Ceratherm 600-2/3 Radiant Warmers

Installation Instructions for casing, part number 521-7198-3

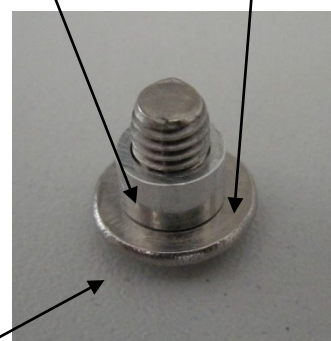
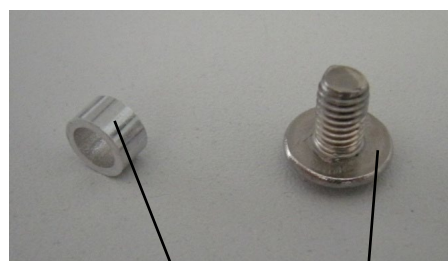
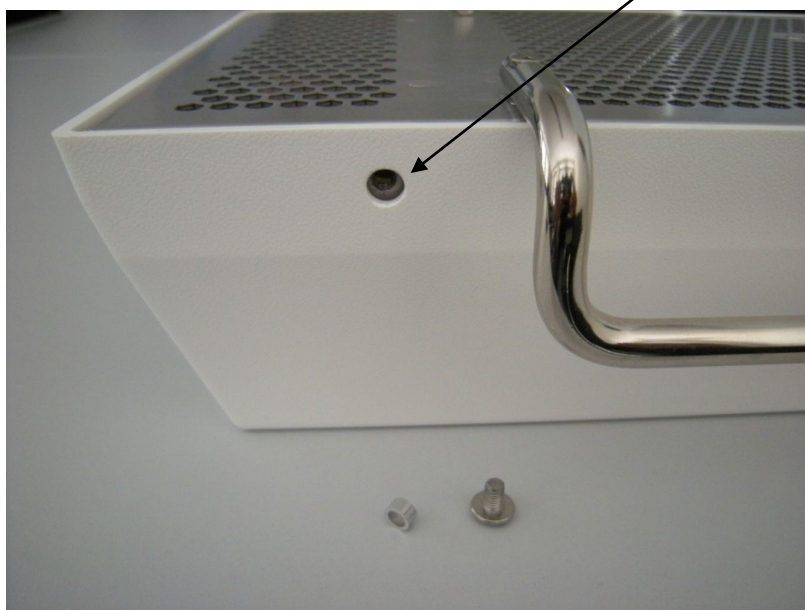
- The new casing (part number: 521-7198-3) has six holes, each with a diameter of 8 mm (previously 6 mm).

- The existing six mounting screws (M5 x 8) should be assembled with the supplied 7.0 x 1.0 x 4.0 support sleeves (part number: 521-79940100.10, set of 6).
- Each screw should then be fitted, together with a support sleeve.

- Using a screwdriver, tighten by hand until the screw stops. The screw head rests on the sleeve (not on the casing).
